PILGRIM NUCLEAR POWER STATION UNIT NO. 1

AMENDMENT TO FACILITY OPERATING LICENSE

Amendment No. 15
License No. DPR-35

ATTACHMENT TO LICENSE AMENDMENT NO. 15

Figure 2.1.1

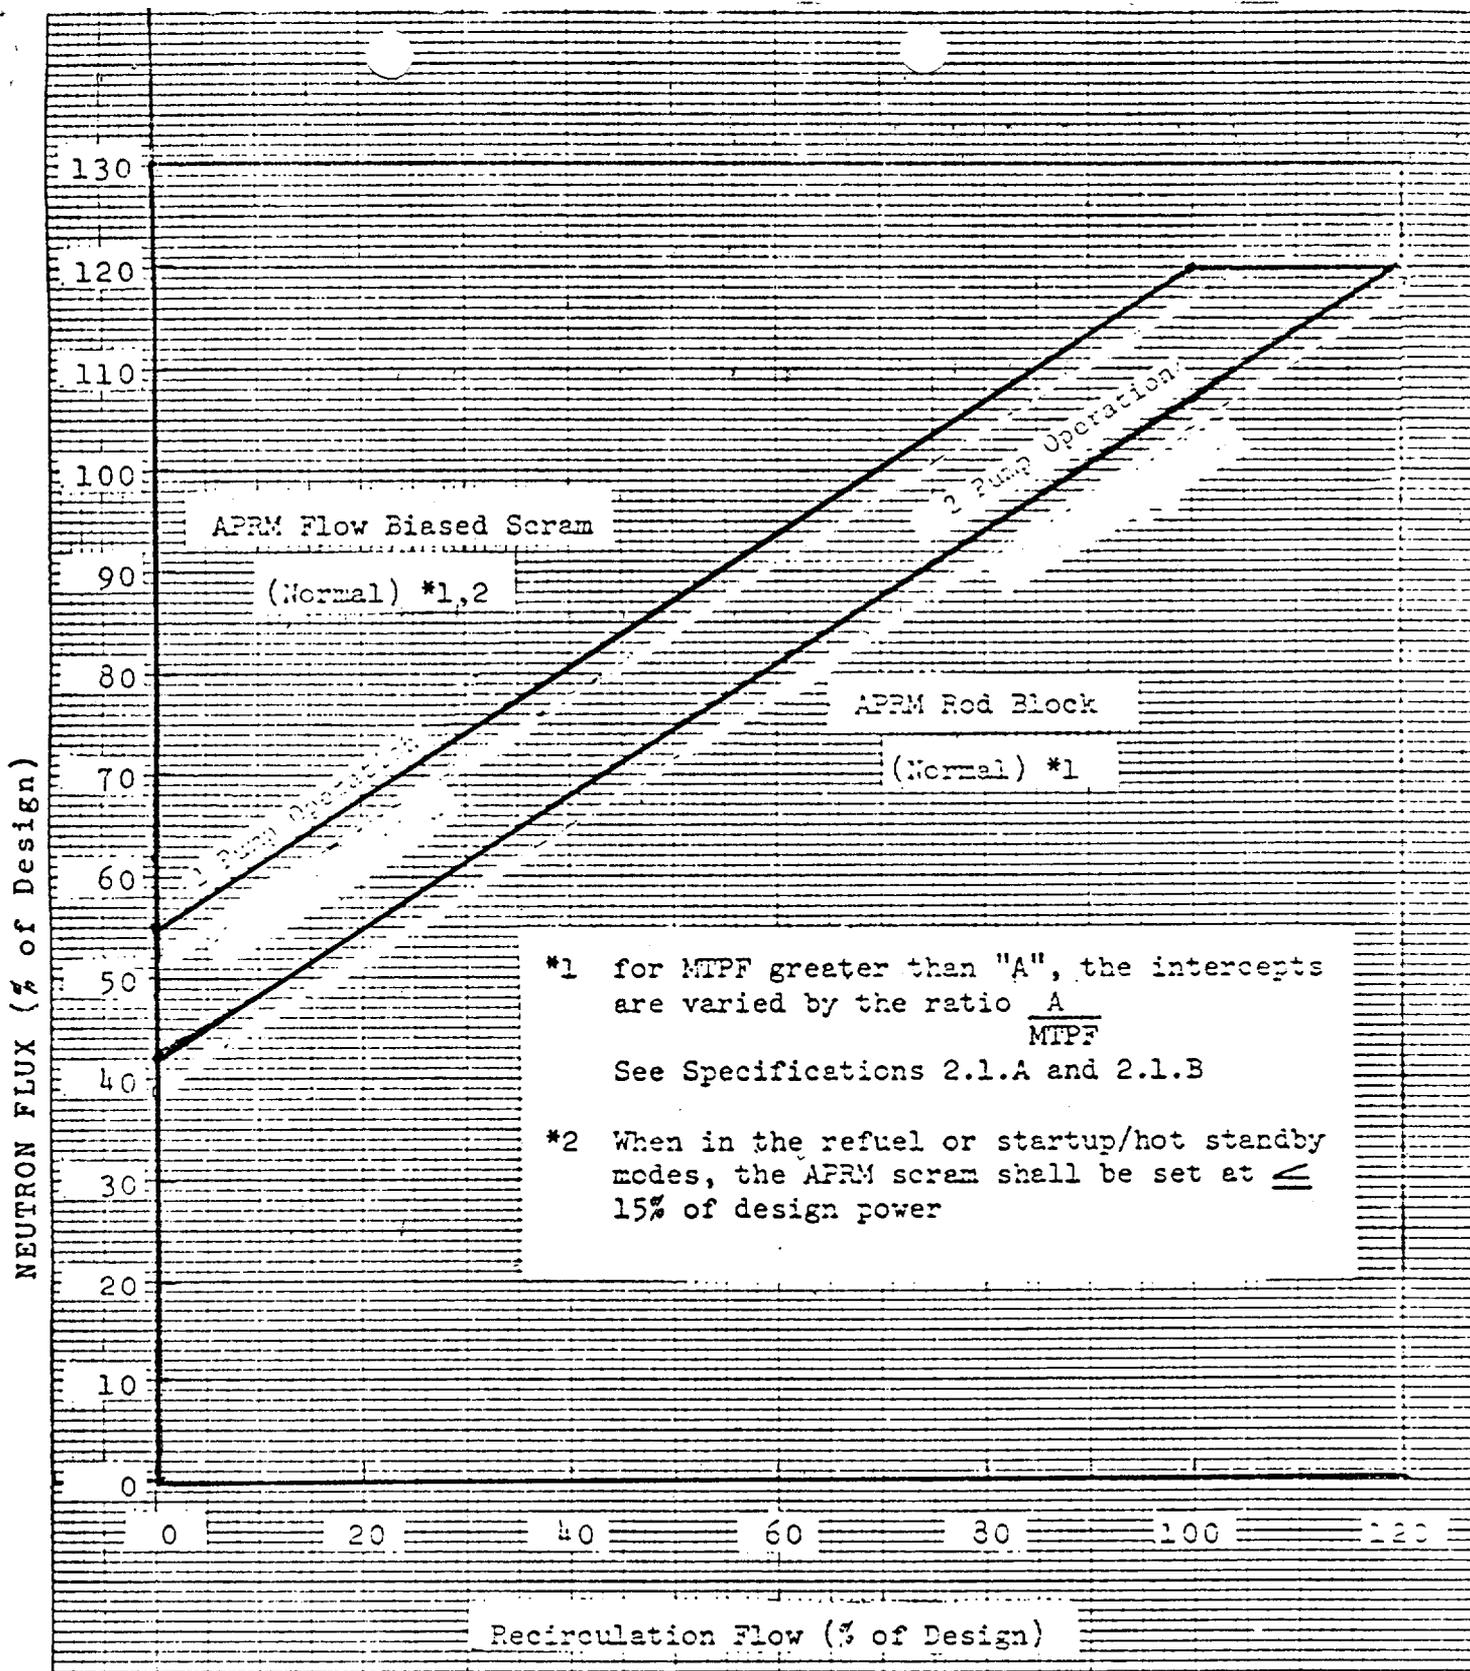
The flow biased scram plotted on Figure 2.1.1 is based on recirculation loop flow. Figure 2.1.3, which shows the flow biased scram as a function of core flow, has also been included.

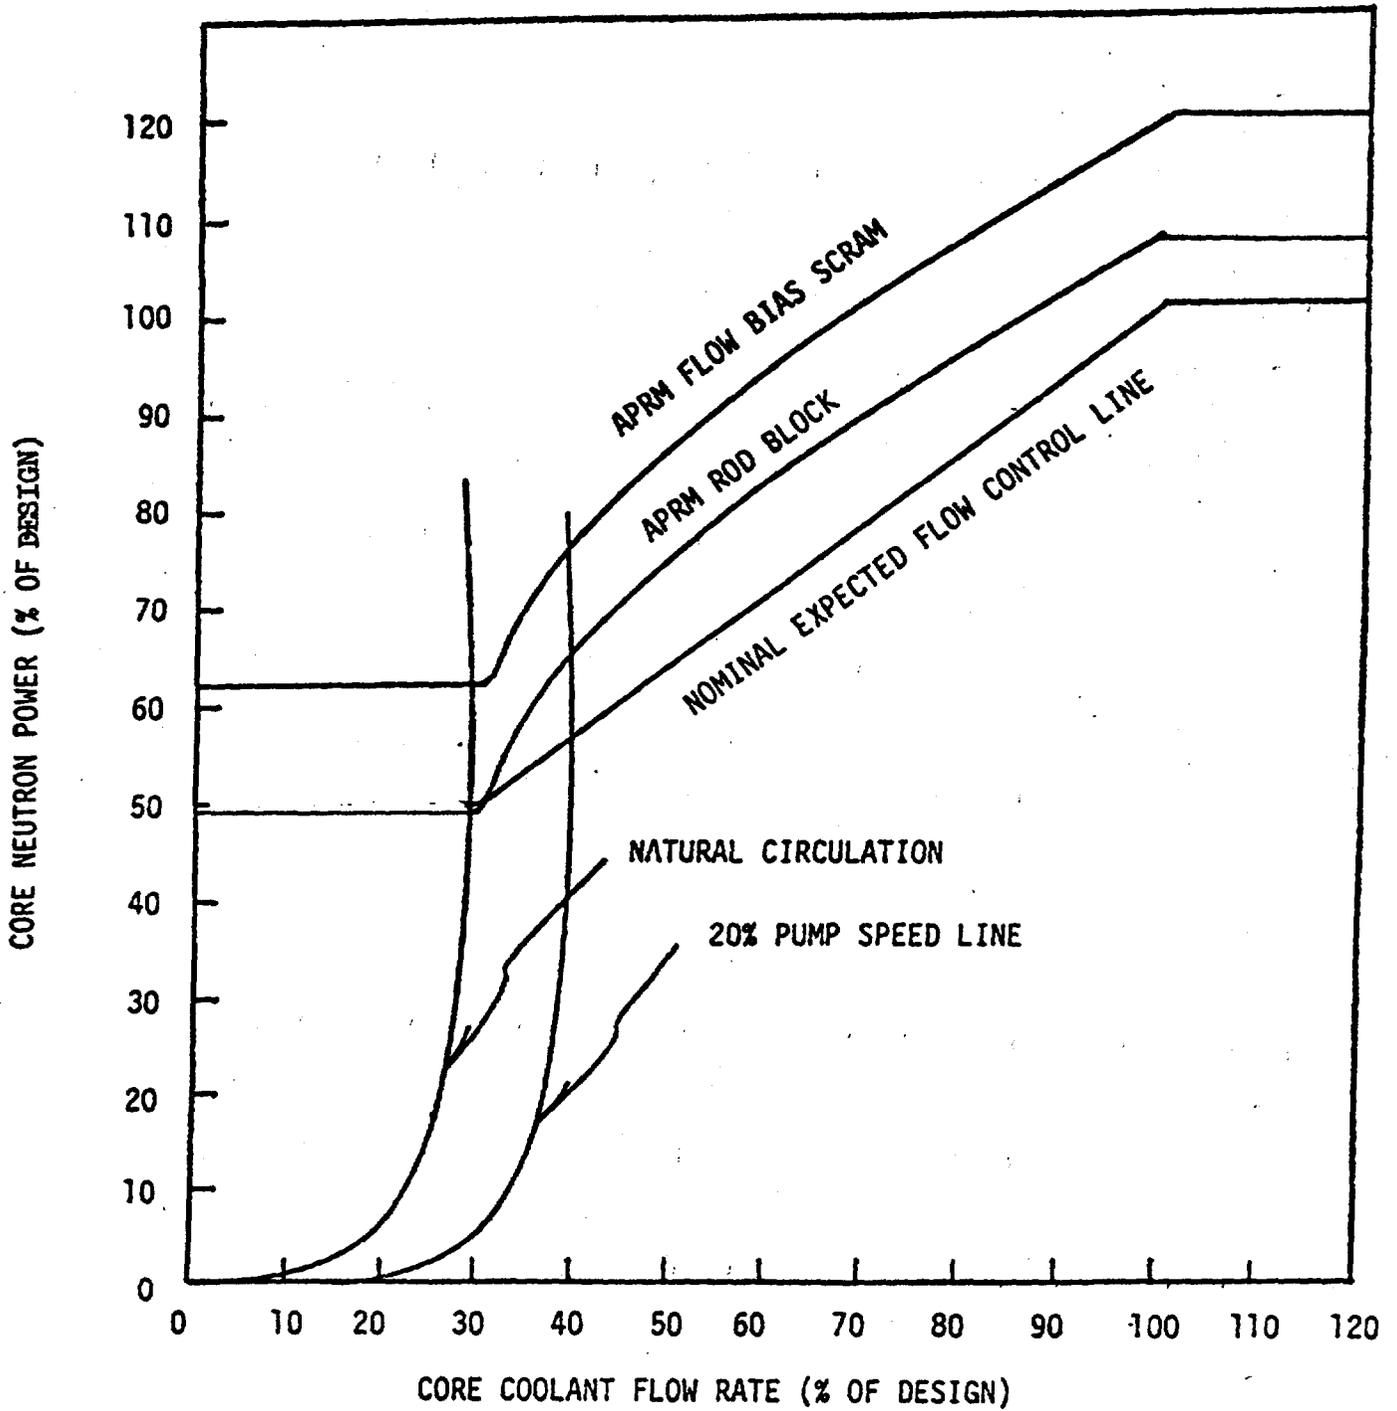
Figure 2.1.3 above represents the APRM flow bias scram with neutron flux plotted against core coolant flow rate instead of recirculation loop flow as shown in figure 2.1.1.

FIGURE 3.11-8

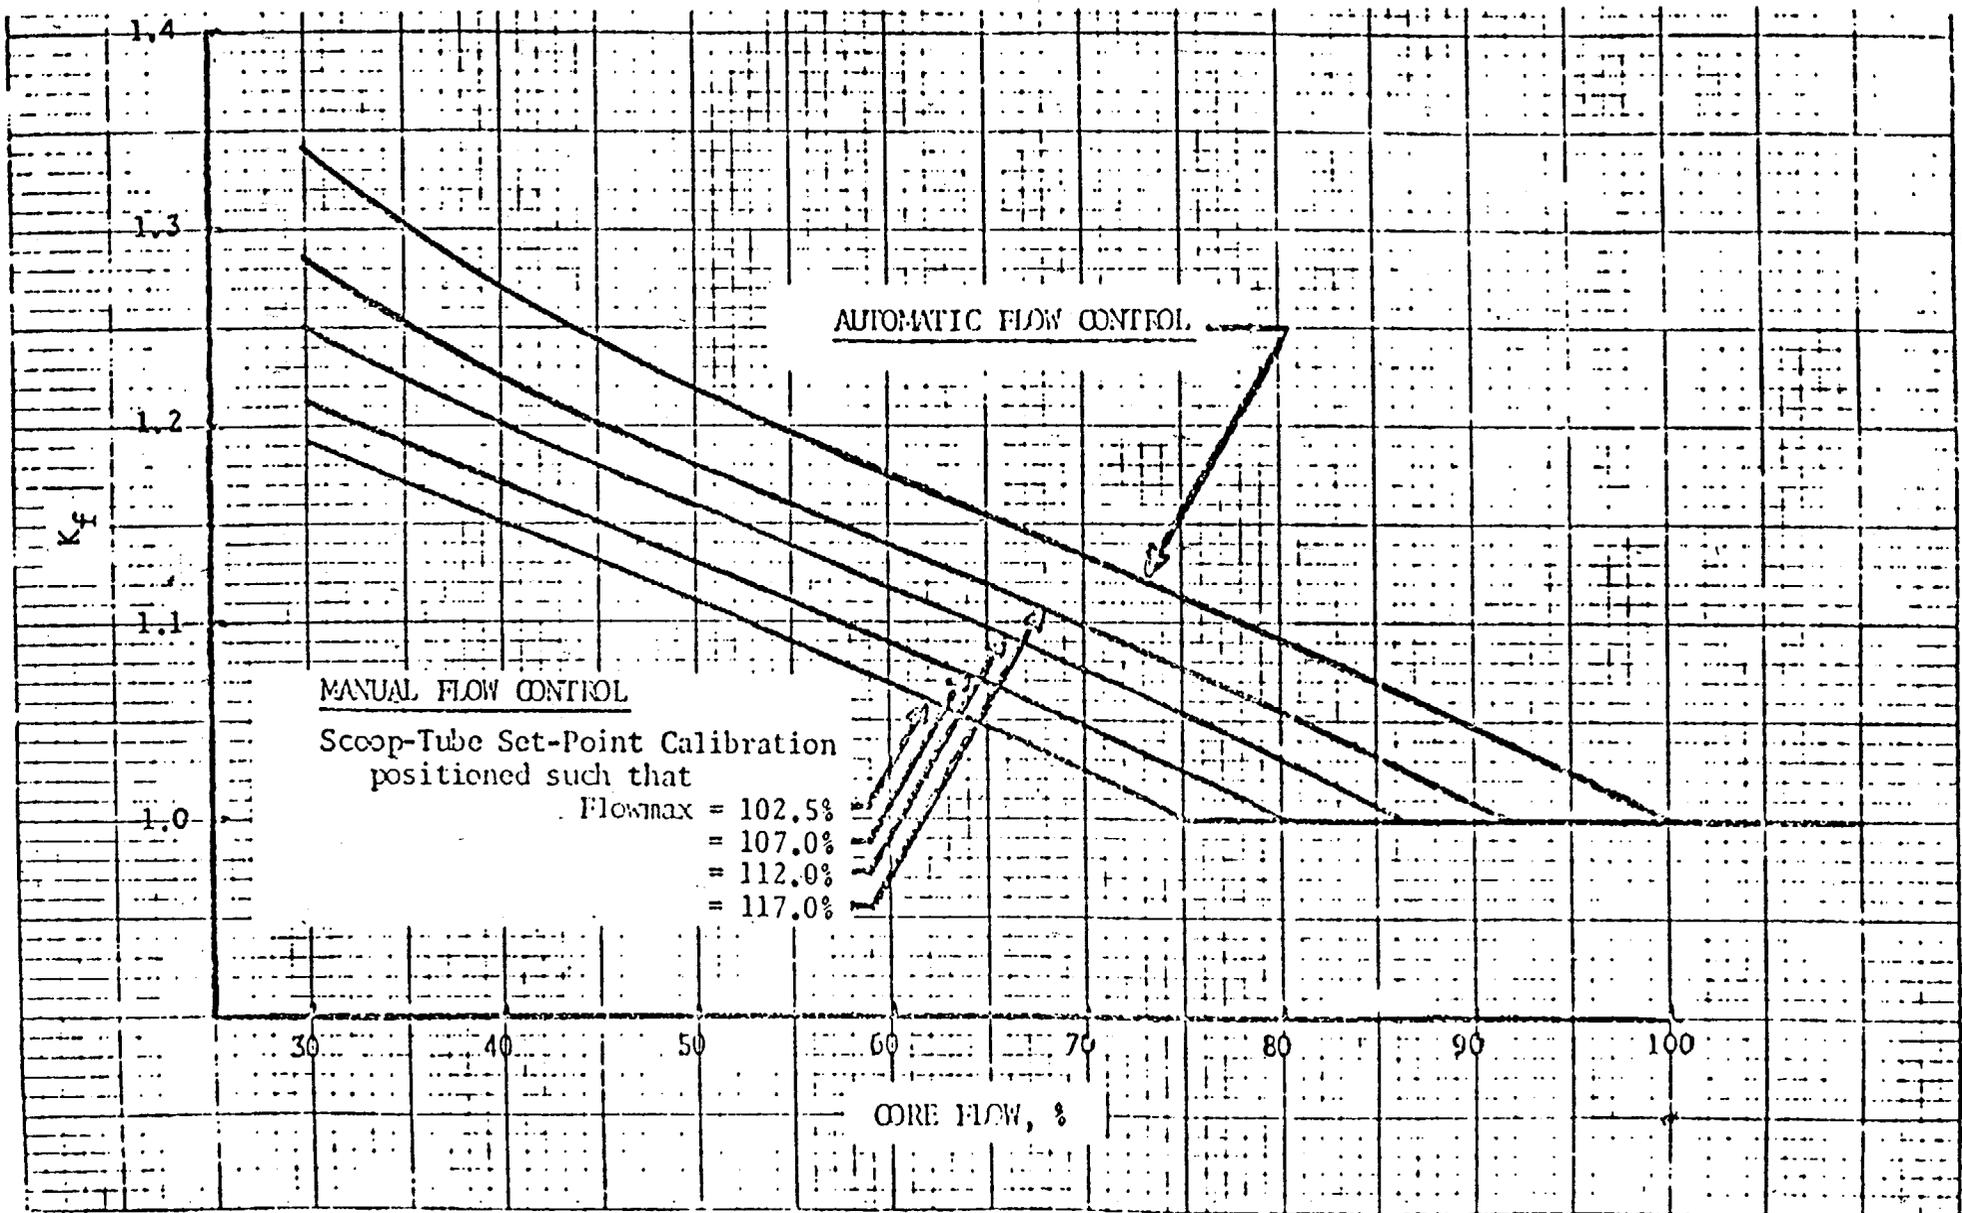
(5)
The K_f factor curves shown in Figure 3.11-8 were developed generically which are applicable to all BWR/2, BWR/3, and BWR/4 reactors. The K_f factors were derived using the flow control line corresponding to rated thermal power at rated core flow.

The K_f factors shown in Figure 3.11-8⁽⁵⁾ are conservative for the Pilgrim Unit 1 operation because the operating limit MCPR's shown in 3.11.1 are greater than the original 1.20 operating limit MCPR used for the generic derivation of K_f .

For core flows other than rated the MCPR shall be ≥ 1.31 for 7 x 7 fuel and ≥ 1.39 for 8 x 8 fuel times K_f , where K_f is as shown in Figure 3.11-8.

As an alternative method providing equivalent thermal-hydraulic protection at core flows other than rated, the calculated MCPR may be divided by K_f , where K_f is as shown in Figure 3.11-8.
